Inland Rail Narrabri to North Star - EIS Public Exhibition

Narrabri to North Star Inland Rail Project – Environmental Impact Statement

OEH Detailed Comments on Biodiversity

Figure 2. Comparison of the proponent's vegetation mapping with the Border Rivers Gwydir/Namoi State Vegetation Map (SVM). The maroon polygon identifies the extent of PCT27 compared to the SVM extent in the purple polygon.

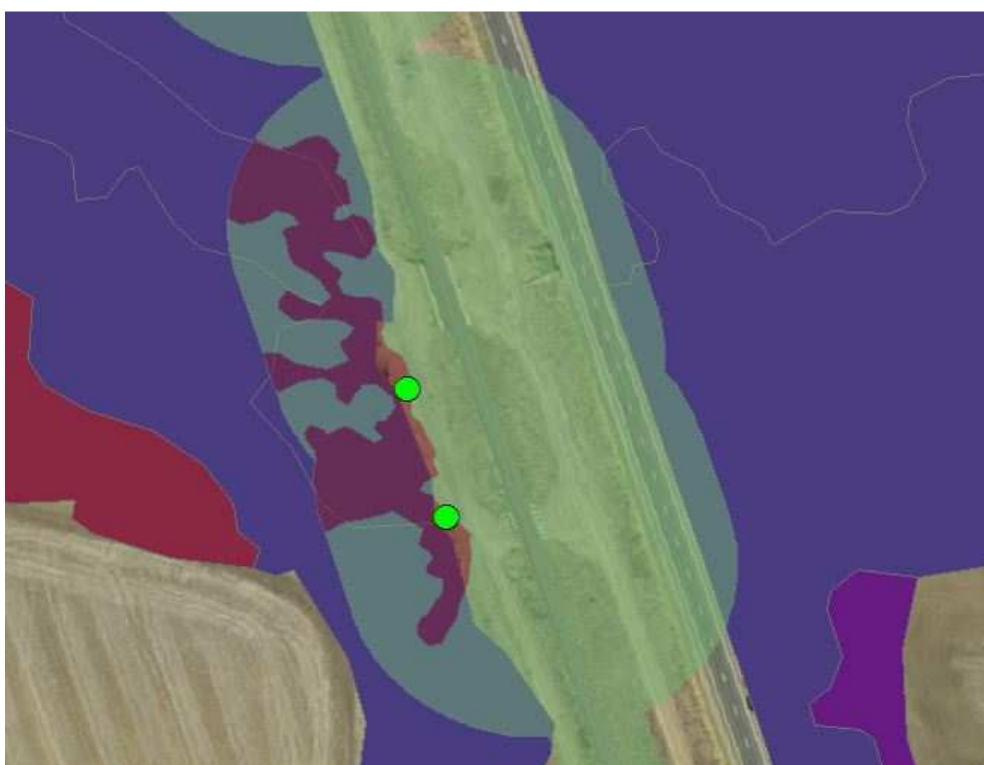
There appears to be areas of native vegetation that have not been captured by the proponent in their native vegetation data layers. Figure 1 in Attachment B provides an example of this – the red polygon identifies PCT27 and the green shapefile identifies non-native vegetation. The top green dot depicts a flora plot location and the bottom green dot depicts a rapid vegetation assessment location. The flora plot field data sheet confirms that the site conforms to PCT27; however, OEH do not have the rapid vegetation assessment data. Unfortunately, there are no plots in the area that has been classified as non-native vegetation to justify the delineation of the polygon boundaries. In comparison, the Border Rivers Gwydir/Namoi SVM (shown in Figure 2) indicates that all the underlying vegetation has been mapped as PCT27 rather than just a portion of it.

Figure 5. The proponent's mapping classifies this area as cleared/non-native.

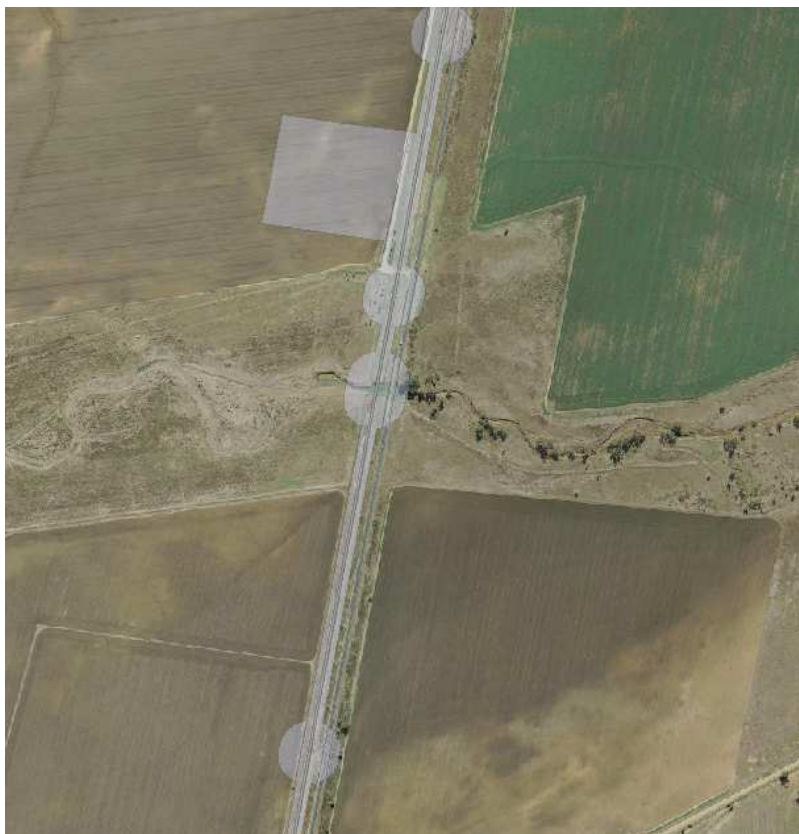
Figure 5 shows an area that has been mapped as cleared/non-native (light pink transparent polygon) but the underlying ADS40 imagery appears to show an area of native vegetation through the centre of the figure. There are no flora plots or rapid vegetation assessment plots at this location to confirm the flora species that are present. When the Border Rivers Gwydir/Namoi SVM is reviewed (Figure 6) it suggests that the same area is comprised of three separate PCTs (dark blue, light blue and red polygons). Again, this under-estimation of the extent of native vegetation will result in an under-estimation of the biodiversity credit liability.

Figure 8. Belson's panic and finger panic grass recorded within the development footprint.

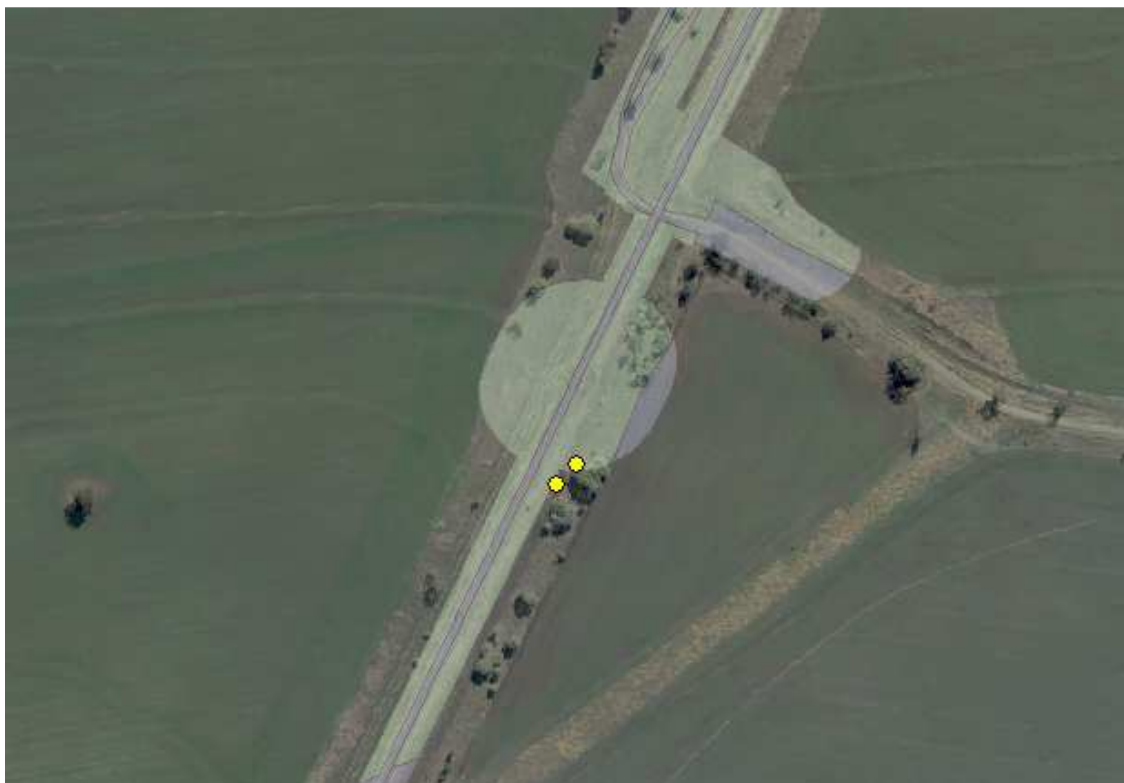
OEH notes that there is a number of locations along the development footprint where there may be the potential to avoid impacts to recorded threatened flora species. Figure 8 shows the location of a record of Belson's panic (upper yellow dot) and finger panic grass (lower yellow dot). By reducing the impact associated with the culvert at this particular location it could potentially avoid impact to these two species. Similarly, Figure 9 shows records of creeping tick-trefoil where a reduced impact footprint could avoid impacts to numerous individuals. Any avoidance, particularly to Belson's panic which the Threatened Species Profile Database states could not withstand further loss, would be a positive outcome.
